MODULAR INTERCOM PRODUCTS UPGRADE

Modular Intercom Upgrade

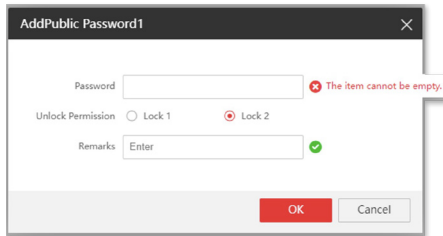
Original Model:
 DS-KD8003-IME1
 DS-KD8003-IME1/Surface
 DS-KD8003-IME1/Flush
 DS-KIS602

New Upgraded Model:

DS-KD8003-IME1(B)
 DS-KD8003-IME1(B)/Surface
 DS-KD8003-IME1(B)/Flush
 DS-KIS602(B)

New Features

Separate Pin Code for 2nd Lock and Remark

Built-in Web GUI

Power Supply for Locking Device

This "12VDC" interface is 12V in/out. When the device is powered by POE, this interface will supply DV 12V 500mA.
